ECE/TRANS/WP.29/GRE/2006/47/Rev.1  
18 January 2008

Proposal for draft amendments (Revision 2) to Regulation No. 113  
(Headlamps emitting a symmetrical passing beam)

Submitted by the expert from the International Motorcycle Manufacturers Association  
(IMMA) \*/

**Figure 12: Class E in respect of the passing beam and driving beam.**

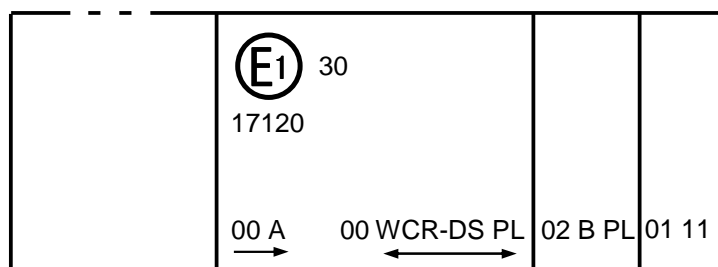
**Figure 11: Class E in respect of the passing beam only.**

Figure C

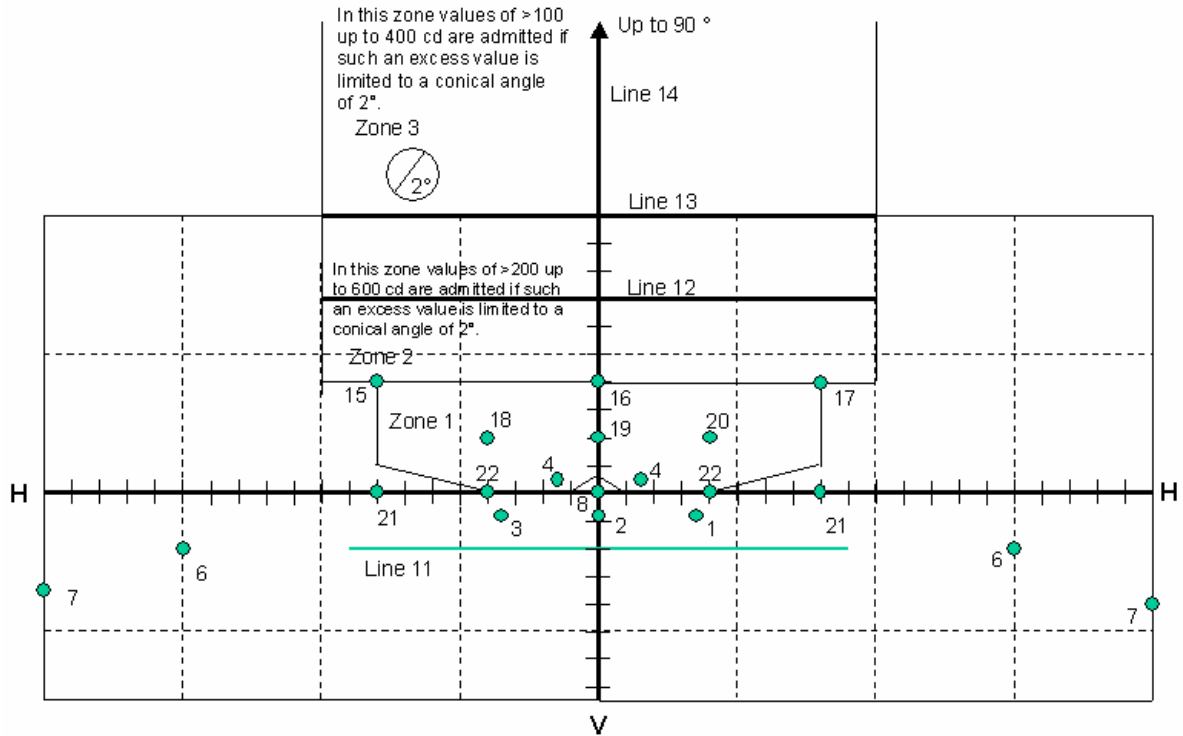
MEASURING SCREEN  
for Class C, **D** and **E** headlamps  
(Dimensions in mm with screen at 25 m distance)

**Note:** The luminous intensity of zones 2 and 3 above are not applied to Class E.

**CENTRE OF REFERENCE**

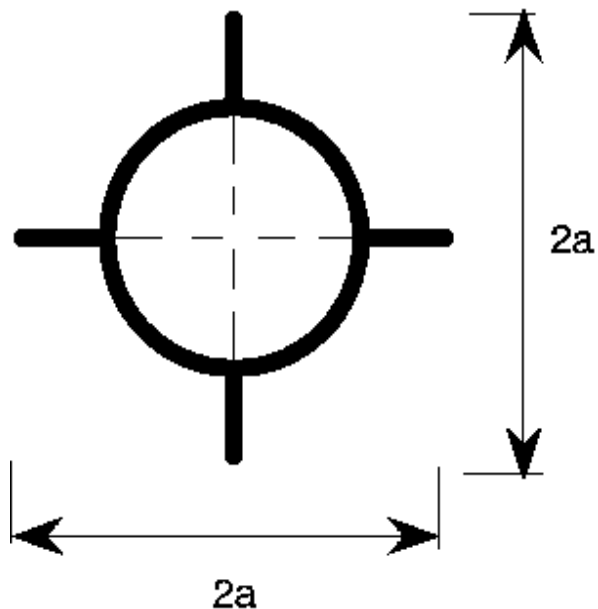
**Diameter = a**

**a = 2 mm min.**

**The above drawing represents the mark of the centre of reference as projected on a plane substantially tangent to the lens about the centre of the circle. The lines constituting this mark may either be solid or dotted.**
